Application for Certificate of Appropriateness for a City Landmark or Local Historic District

Re: Continuing Consultation for the Eliza Spring Outlet Daylighting Project, **Project review under Section 106 and the Antiquities Code of Texas**

Re: *Project review under Section 106 of the National Historic Preservation Act of 1966 and the Antiquities Code of Texas, Eliza Spring Outlet Daylighting Project, Zilker Amphitheater, Zilker Park, Austin, Travis County (106/USACE, NR, SAL)*

Figure 1. A) Current view of Eliza Spring Amphitheater looking northwest; B) Conceptual rendering of the project when complete from the same vantage. Note that the concept drawing does not include the proposed micropile reinforcing wall around the keyhole opening.

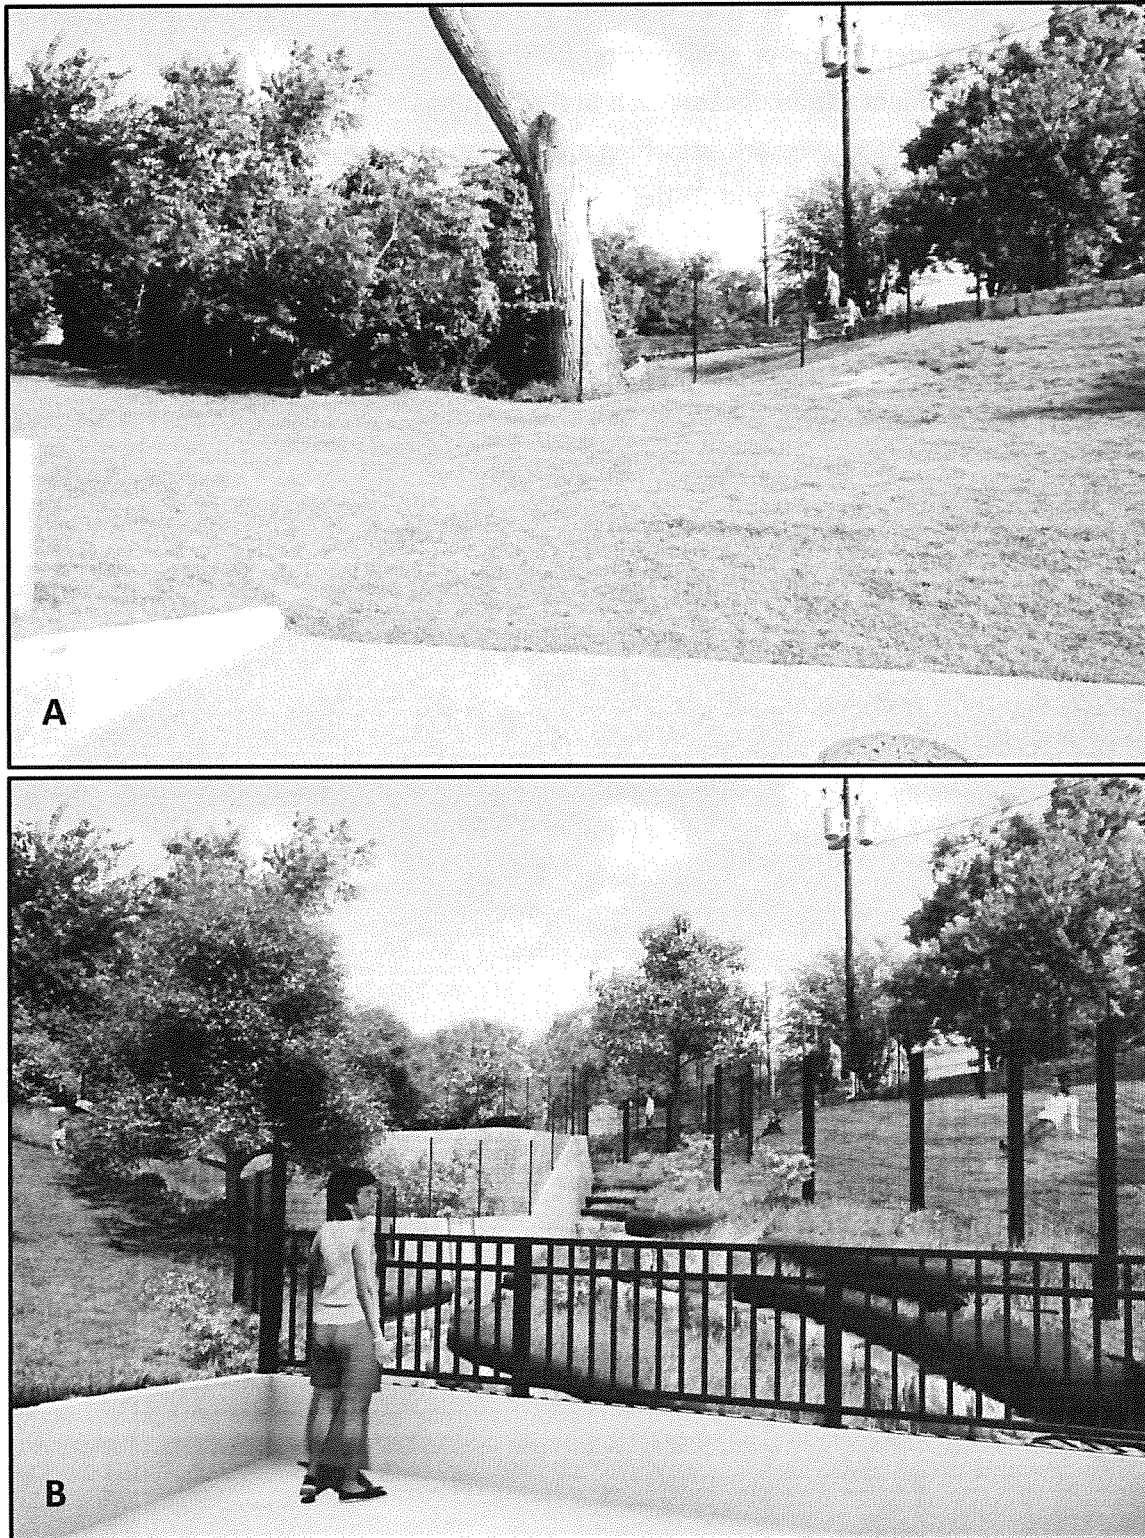
First, removing the earth fill around the structure to re-establish the open stream will expose portions of the amphitheater walls (an unknown portion of which were historically exposed) and potentially put the eastern end of the structure at risk of destabilizing. During the design process several solutions to this problem were considered, including stabilization of the exterior wall using a tie-back and anchor system. However, these solutions were ultimately rejected due to the high sensitivity of the Barton Springs Salamander habitat. Ultimately, to prevent damage or further deterioration of the 1903 structure, while minimizing possibility for impact to the endangered salamander habitat, the final design plans call for construction of a concrete and micropile wall on the exterior of the channel side of the amphitheater (see Plan Sheets C2.1 and S1.8). The wall would range in thickness from approximately 2.5 feet below grade, to less than 5 inches at the top of the amphitheater (see Plan Sheet S1.9). The wall would abut the amphitheater's eastern exterior around the keyhole opening but would not affect the integrity of the amphitheater's interior in any way. Although finish treatments have yet to be determined, these could involve matching concrete color or scoring to the original amphitheater materials, or developing another treatment that would be historically appropriate.

One other design element that we would like to call your attention to is a headwall gate in the keyhole opening (see Plan Sheet S1.4). Although not part of the original structure, the headwall gate would be necessary to control stream flow and water levels, and preserve salamander habitat. Although not integral to Zilker's original design for the amphitheater, we believe that the addition of the headwall gate would not adversely affect the structural or cultural integrity of the resource.

APPROXIMATE AREA OF POTENTIAL EFFECTS

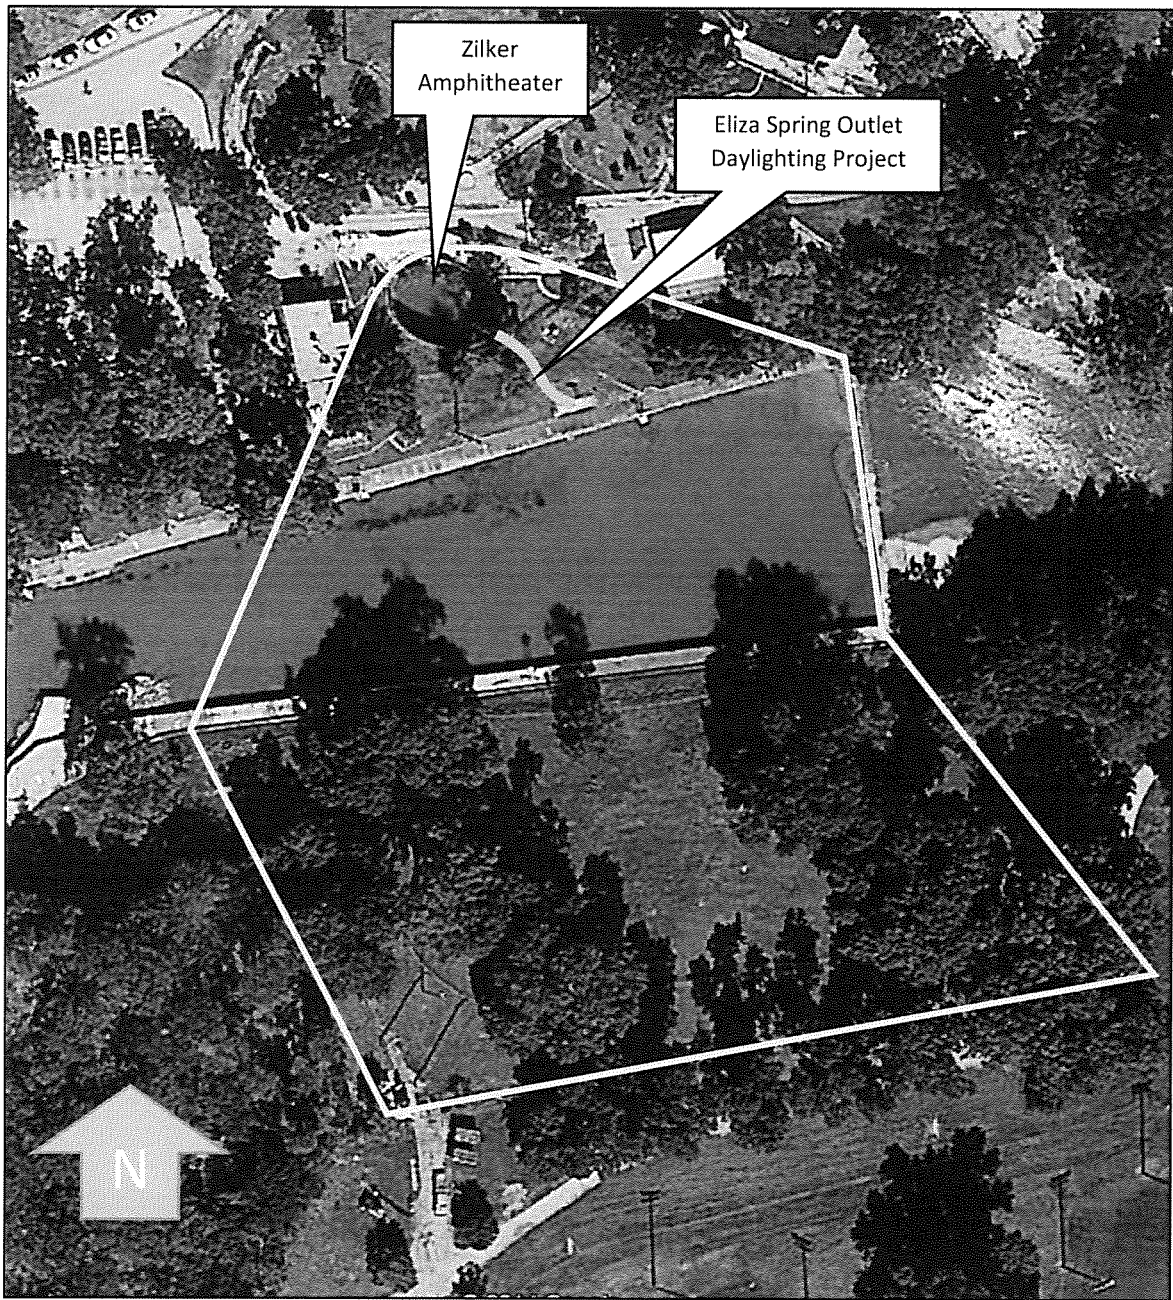
We **CONCUR** with the Area of Potential Effects proposed for this project, described as the areas from which the improvements will be visible. This is shown on the enclosed diagram as encompassing the Zilker Amphitheater, a portion of the Barton Springs Pool, and an area of the park on the opposite bank.
